# Comment on “Impact of Load Frequency Dependence on the NDZ and Performance of the SFS Islanding Detection Method”

Olivier Argence, *Student Member, IEEE*, Bertrand Raison, *Senior Member, IEEE* and Florent Cadoux, *Member, IEEE*

**Abstract**—We read with interest an article [1] published in the *IEEE Transactions on Industrial Electronics* in 2011 and tried to reproduce the results of this article for the needs of our own research. Unfortunately, we were led to think that the load model equations used by the authors contained an inconspicuous but significant mathematical error, leading to erroneous results and conclusion. The present paper brings a correction to some figures and their analysis as well as the paper conclusion. The new results show that the load’s frequency dependence has actually no significant impact on the NDZ of the SFS method.

Fig. 2. (Corrected version of Fig. 6 from [1]) Load characteristic with and without frequency dependence, using “pu/pu” for  $k_{pf}$ .

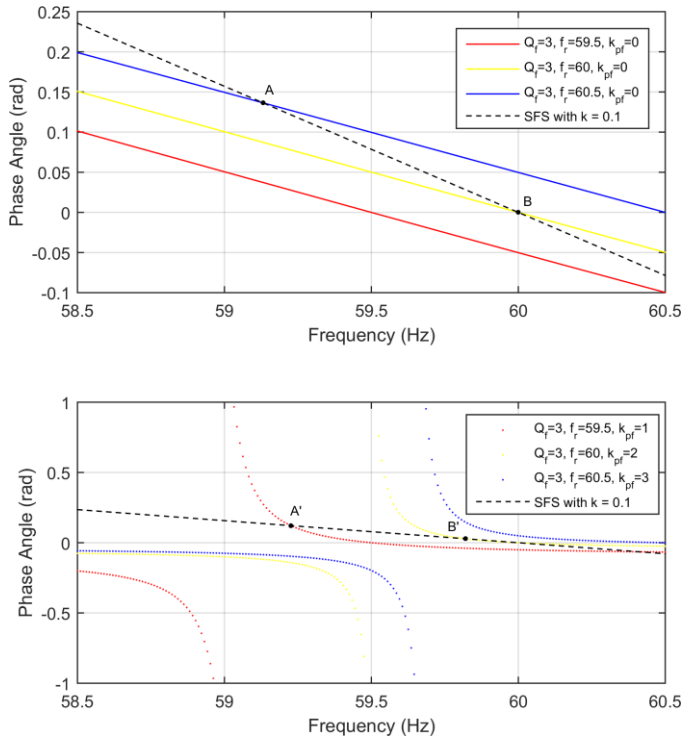
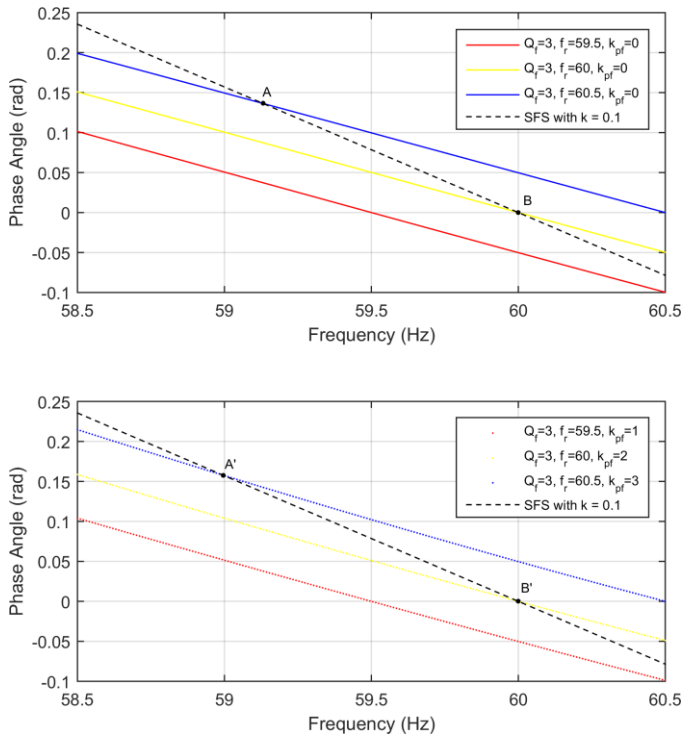
To confirm our hypothesis, we plotted Figure 6 from [1] which is an easy to understand figure as it directly based on (2) — which is the equation (11) from [1] with a correction of a typo on the sign. We plotted it twice, first using the wrong unit “pu/Hz” for  $k_{pf}$ , see Fig. 1, and get exactly the same curves as Figure 6 from [1], which confirms our suspicion; then with the correct unit (pu/Hz), see Fig. 2, and we can see that the frequency dependency actually barely has any impact on the load characteristics.

Fig. 3. (Corrected version of Fig. 2 from [1]) Load and SFS phase angle–frequency characteristic for a load with  $f_r = 60$  Hz.

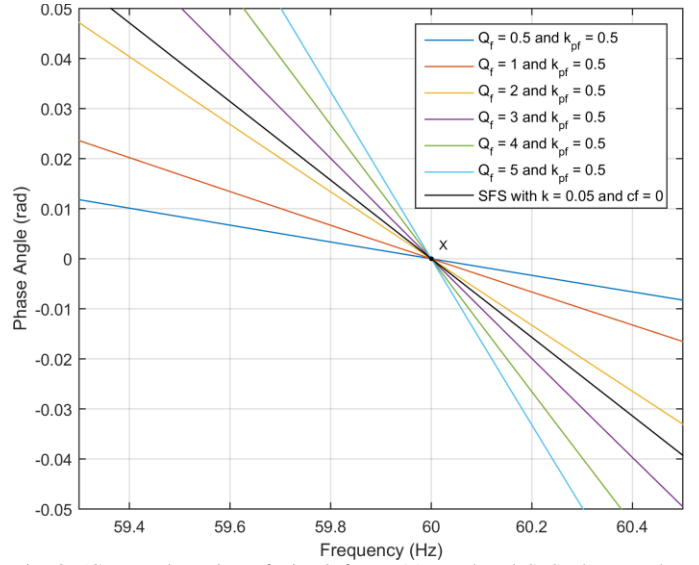
“In Fig. 3, the load’s quality factor is varied between 0.5 and 5 while  $f_r$  and  $k_{pf}$  are set fixed at 60 Hz and 0.5, respectively. Based on the phase angle criterion, in order to eliminate the NDZ of the SFS method, the *distributed generator* (DG) phase angle curve should be steeper (higher absolute slope) than the load phase angle curve. For loads with  $Q_f \geq 3$ , the frequency will stabilize within the IEEE threshold values (59.3 and 60.5 Hz) and thus frequency relays will fail to detect islanding. For the case where  $Q_f \geq 3$ , the frequency will stabilize at 60 Hz (Point X).”

Fig. 4. (Corrected version of Fig. 3 from [1]) Load and SFS phase angle–frequency characteristic for a load with  $f_r = 60$  Hz and  $Q_f = 3$  for various values of  $k_{pf}$ .

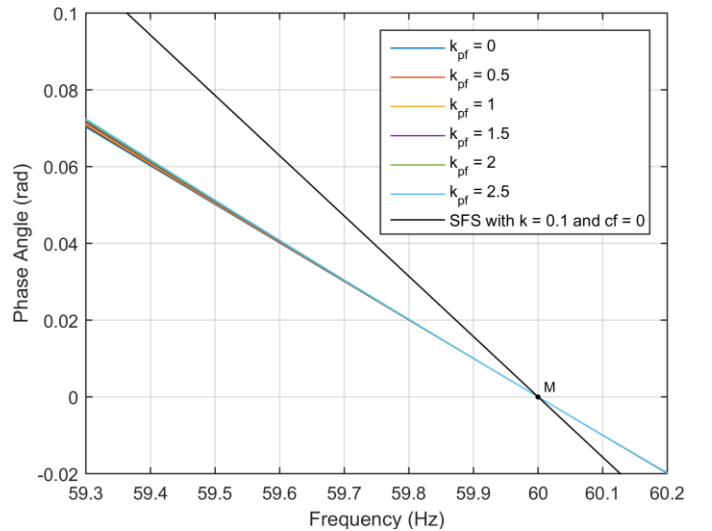
“Fig. 4 shows the load and DG phase angle–frequency characteristic for a DG equipped with the SFS islanding detection method for various values of  $k_{pf}$ . [...] From Fig. 4, it is shown that as the value of  $k_{pf}$  has little impact on the load phase angle–frequency curve and does not affect the islanding detection capability of the SFS method. [...] The analysis shows that the load’s active power frequency dependence is a secondary factor to consider when designing islanding detection methods.”

Fig. 5. (Corrected version of Fig. 4 from [1]) NDZ for the SFS method with  $cf=0$  and  $k=0.05$  for different values of  $k_{pf}$  with  $Q_f=4$ .

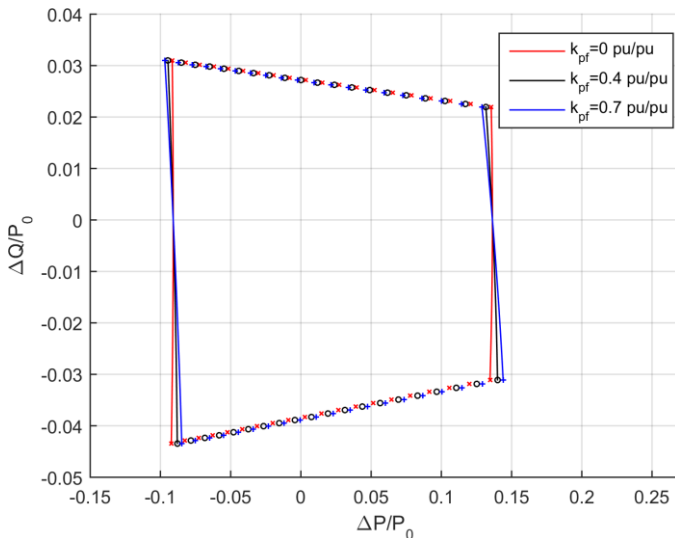
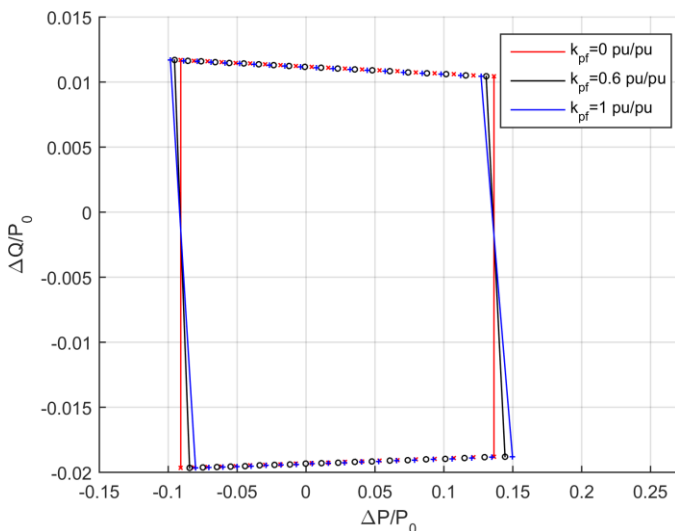
“Figs. 5 and 6 show the NDZ of the SFS under two different design cases for different values of  $k_{pf}$ . For the two presented cases, the NDZ of the SFS method almost does not change with the change in  $k_{pf}$ . [...] Similar conclusions could be drawn for the case where  $cf = 0.001$  and  $k = 0.005$ . The SFS method would not fail to operate correctly for large active power mismatches as a result of the load’s active power frequency dependence.

[...] the presented NDZ shown in Figs. 5 and 6 correspond to the steady-state performance. The steady-state NDZ is a

conservative measure of the NDZ but the actual NDZ (taking into account transient behavior) could be smaller.”
